Urban Design Review Panel Report

1822 Bank Street

**RE: Urban Design Review Panel Report
Official Plan Amendment, Zoning By-law Amendment, and Plan of Subdivision Applications
1822 Bank Street**

VIEW FROM ABOVE NORTHWEST SHOWING 45 DEGREE ANGULAR PLANE

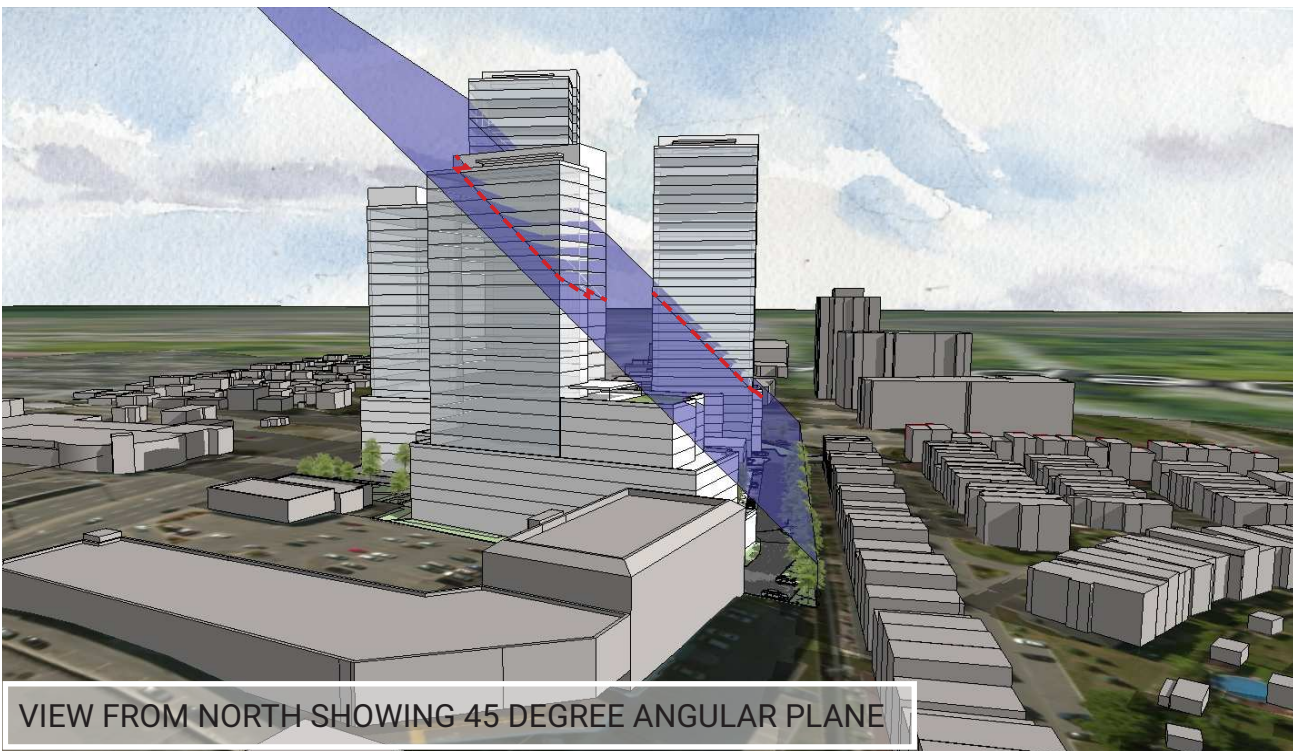
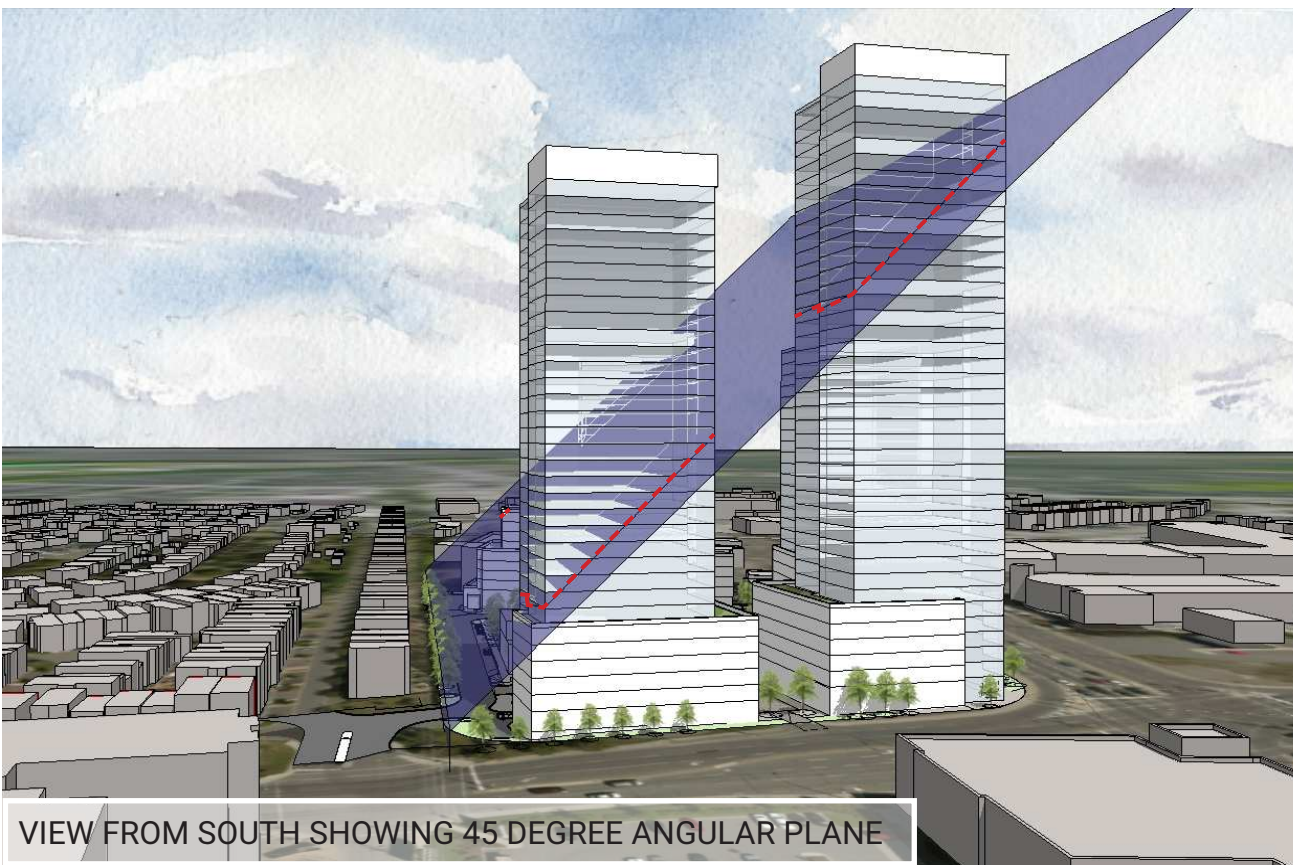
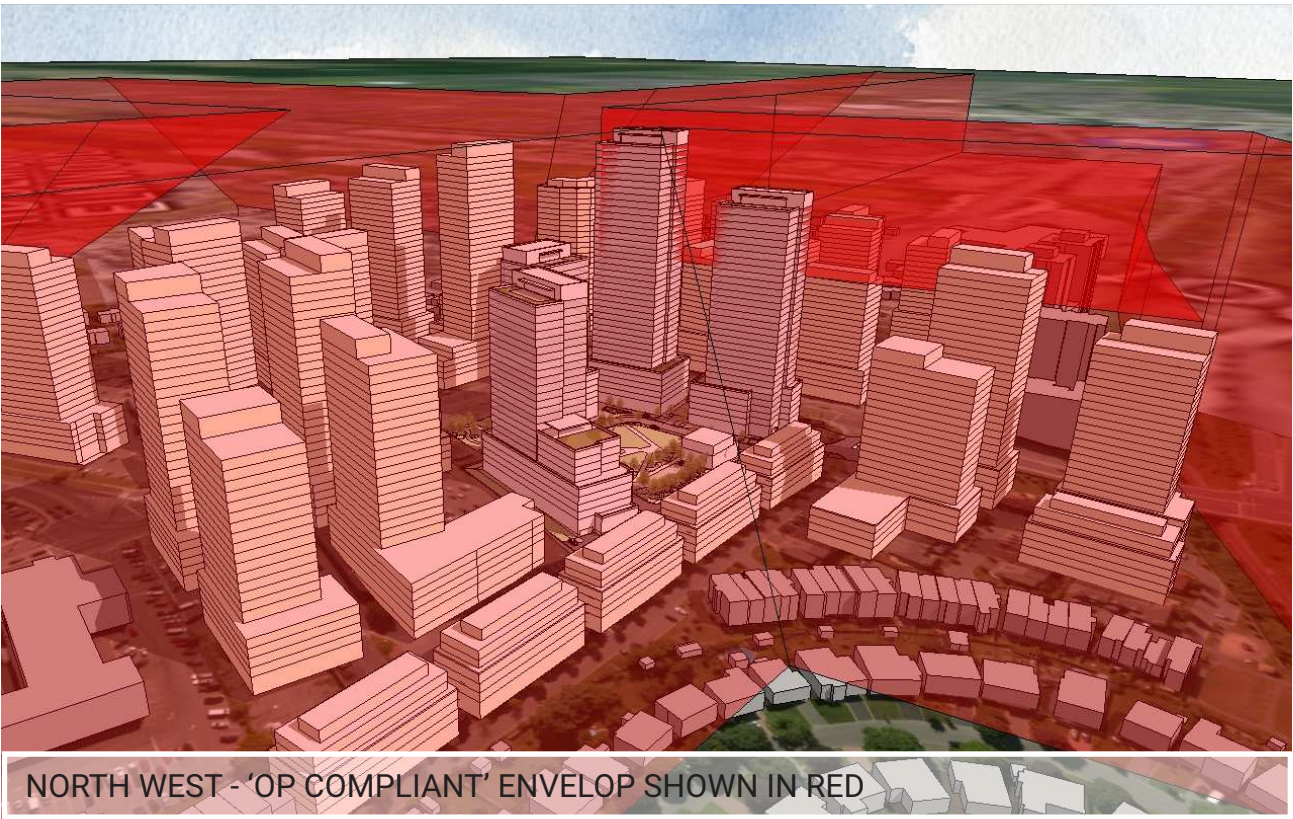
28. The Panel suggests Building 2 on the eastern edge of the site should go taller, bumping right up to meet the 45-degree angular plane shown on p.34 of presentation and perhaps even beyond it.

41. Ensure effective built form transition, guided by the application of angular planes.

Response: Building 3 (formerly Building 2) has been increased in height to 33 storeys. This change offsets the reduction in height on Building 1 (formerly building 5) at the southwest corner.

Applicant: Please refer to the angular plane diagrams included in the UDRP submission set. We feel that the proximity to the transit station and future development potential under the OP justifies some elements of the development breaking the 45 degree angular planes. The trade-off the proposed development offers is providing the majority of the western edge as greenspace. This minimizes the number of the existing townhomes impacted by overlook / shadowing.
